3 HOGAN STREET, BALGOWLAH HEIGHTS

**STATEMENT OF ENVIRONMENTAL EFFECTS FOR
SECTION 4.55 (1A) MODIFICATION TO VARY
DEVELOPMENT CONSENT DA2023/1628**

Report prepared for
Katie Jenks & Graeme Evans
September 2024

Figure 12. Extract from the Modification Plans (MOD07) showing the rear elevation and changes to the roof form at ground floor level (including retention of roof above living room).

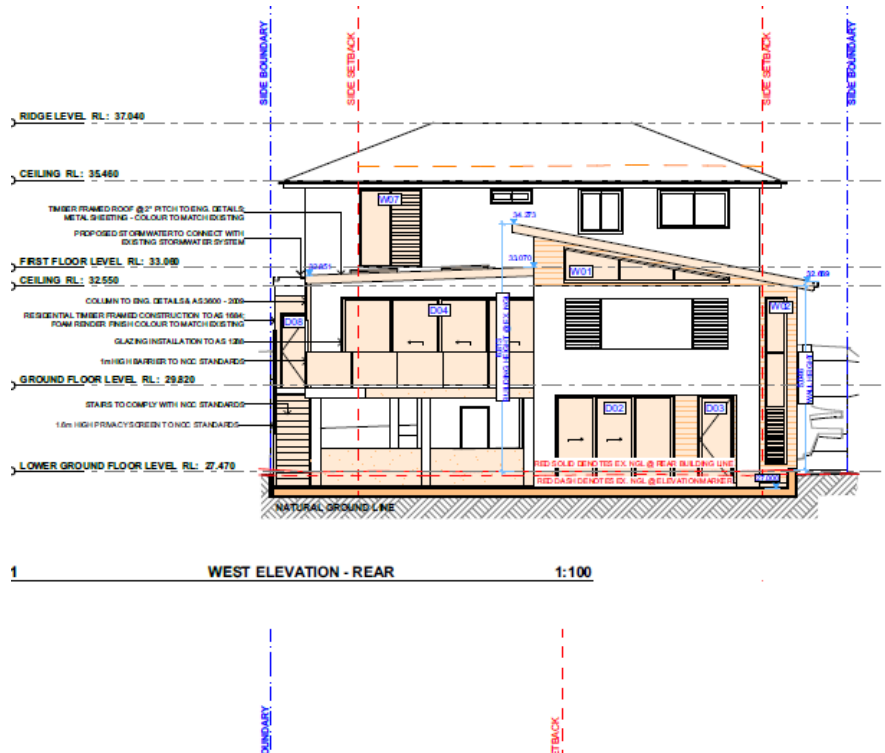
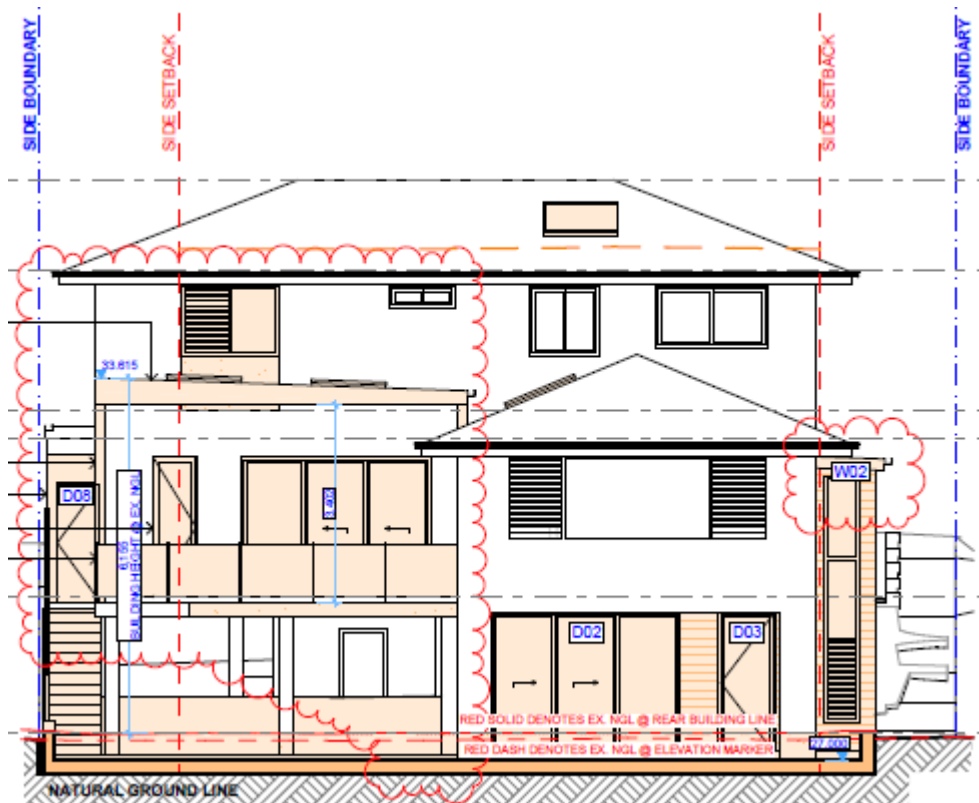
- Retain the existing pitched roof over the living room & kitchen, with the addition of 3 new skylights,
- A new pop-up skillion roof sloping north to south (approved development slopes south to north), with four skylights over. The roof is to be designed so that it appears flat from the underside,
- A laundry in the location of the existing office, including the replacement of the existing window with an access door out to the alfresco area.
- Replacement of existing doors from the dining & living onto the alfresco within the same opening,
- A new bathroom layout (adjacent to bedroom 5), and
- Front entry reconfiguration (D07).

The existing height of the dwelling is to be retained. The maximum building height of the new skillion roof at rear ground floor level is 6.155 metres measured from existing natural ground level (see Figure 12 above).

Figure 14. Extract from the Modification Plans (MOD05) showing the Proposed First Floor Level and the changes to W07 off the master bedroom

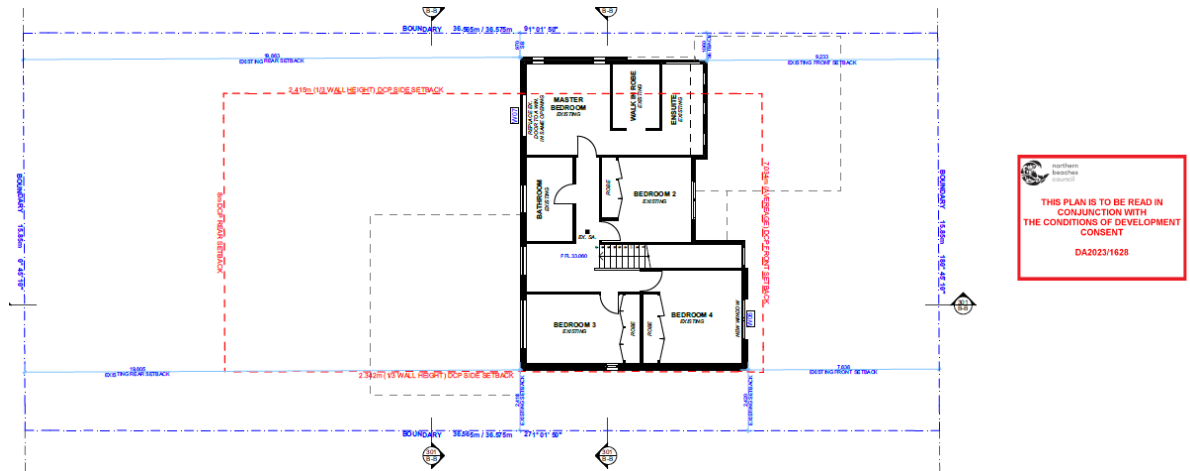
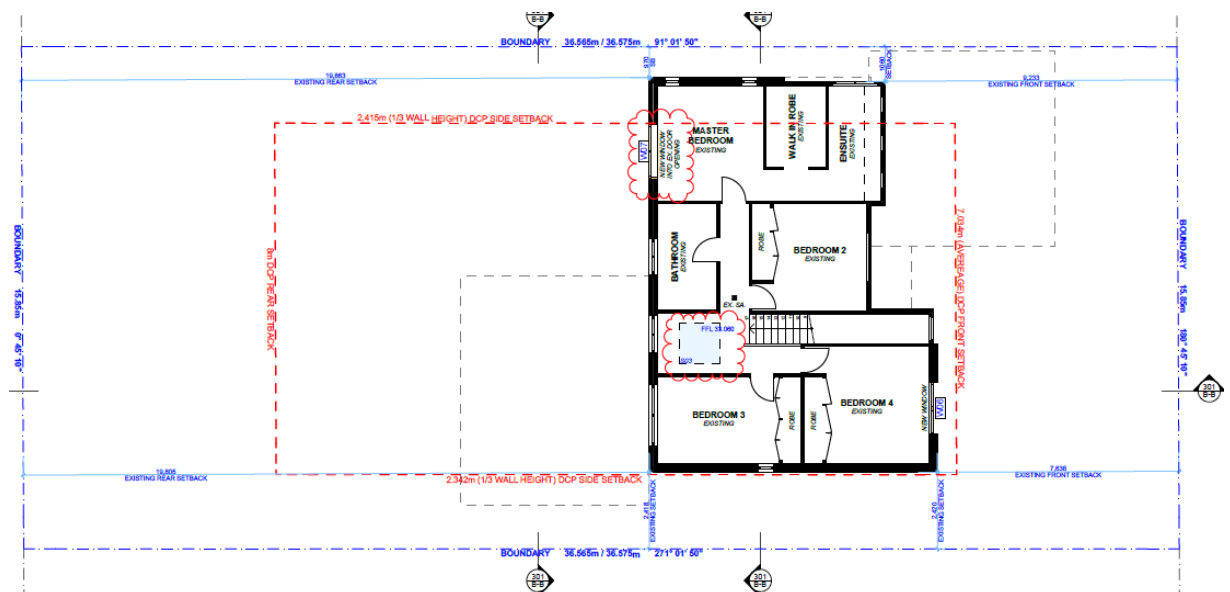
- Replace the Juliette balcony door into the master bedroom with a window, the sill height to match the hallway.
